Pending Amendments to Clauses in the Griffith University Design Guidelines & Procedures Version 18

Edition 18.5

Diagram 18.i

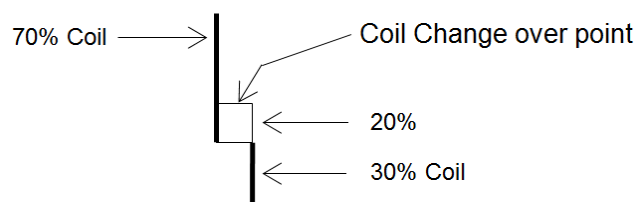
- If the load requires less than 50% of the cooling capacity of the large coil and the small coil is closed down, then the small coil shall be reactivated and the CW flow to both coils modulated to decrease the capacity of the large coil and increase the capacity of the small coil

- When the load has once again exceeded the 100% cooling capacity of the small coil, then the CW flow control outlined above will commence a new cycle.

The object of this operating strategy is to achieve the maximum amount of cooling required for the minimum amount of the coil cooling capacity available. This will also de-humidify the air and provide the potential to maintain comfort levels while allowing the temperature set point to be raised, with a consequent saving in energy.

Diagram 18.iii

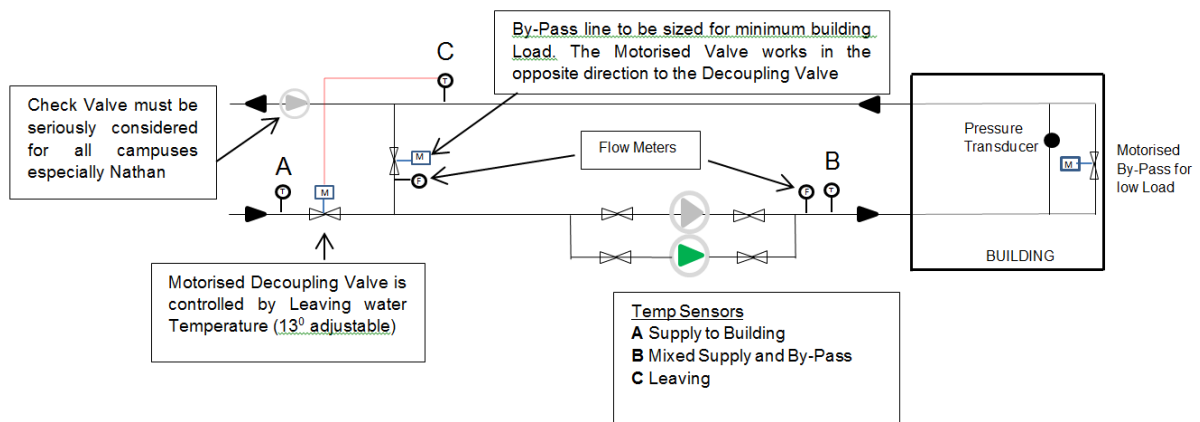
Insert following new paragraph between the existing fourth and fifth paragraphs;

Secondary Chilled Water Pipework Layout – The supply and return pipework within a building, shall incorporate the secondary pipework and control/monitoring valves and equipment as shown on the following Diagram 18.iii to maintain consistent water flows and temperature control throughout the building pipework system.
